SUNDRY NOTICES AND REPORTS ON WELLS
Do not use this form for proposals to drill or to re-enter an abandoned well. Use form 3160-3 (APD) for such proposals.

GCU 157E
30-045-26398

Re: Permanent Abandonment
Well: 157E Gallegos Canyon Unit

CONDITIONS OF APPROVAL

Proposed Wellbore Diagram

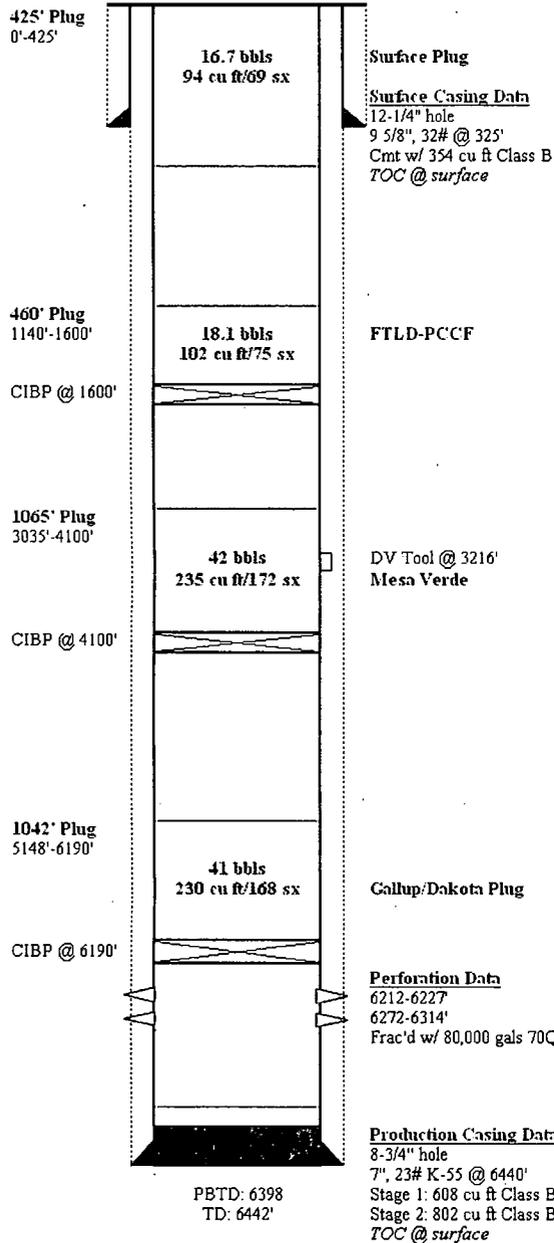
Add Mavros plug from 4550 - 4650

1. Pull tubing
2. Set CIBP @6190'
3. Spot 1042' plug from 6190'-5148' to Isolate Dakota and Gallup Formations
4. Set CIBP @ ~~4100'~~ ^{2533 2453}
5. Spot ~~1065'~~ plug from ~~4100'-3035'~~ to isolate the Mesa Verde Formations
6. Set CIBP @ ~~1600'~~ ^{42 14}
7. Spot ~~460'~~ plug from ~~1600'-1140'~~ to isolate the Fruitland and Pictured Cliffs Formations
8. Spot surface plug from 425' to surface
9. Install well marker and identification plate per regulatory requirements.
10. RD MO Location

1. Plugging operations authorized are subject to the attached "General Requirements for Permanent Abandonment of Wells on Federal and Indian Lease."
2. Farmington Office is to be notified at least 24 hours before the plugging operations commence (505) 564-7750.
3. The following modifications to your plugging program are to be made:
 - a) Place the Measverde plug from 2553' – 2453'.
 - b) Place the Pictured Cliffs/Fruitland plug from 1642' – 1174'.
